ADDENDUM NO. 2

PROJECT NAME: TOM SLICK CREEK PARK IMPROVEMENTS

DATE: 9/30/13

CIMS PROJECT NO.: 40-00398

Suggested Stockpile Protection

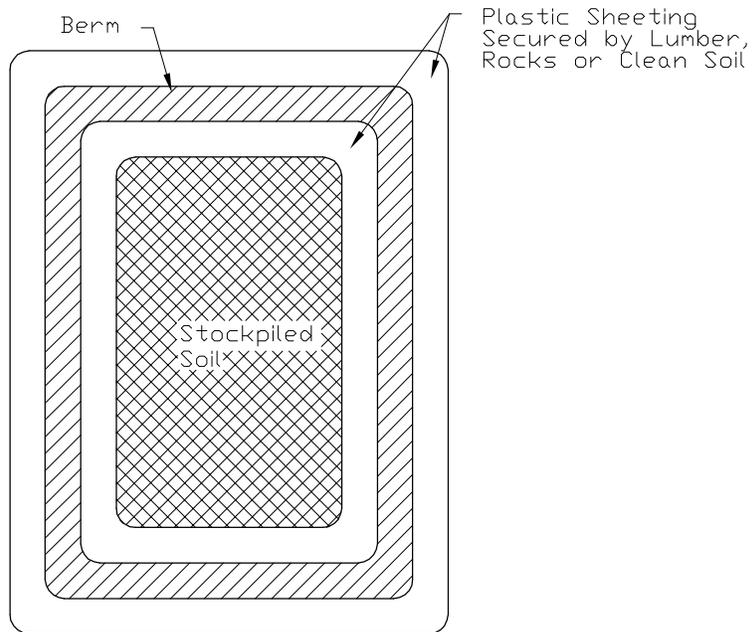
If impacted soils are stockpiled on site, the soils must be placed on and covered by a 10-mil HDPE liner at the end of each working day. The stockpile areas should not be placed in any area of concentrated runoff such as along curbs and adjacent property runoff discharge points. A berm (Exhibit 4) should be constructed around the perimeter of the stockpile area to prevent the impact of surface water.
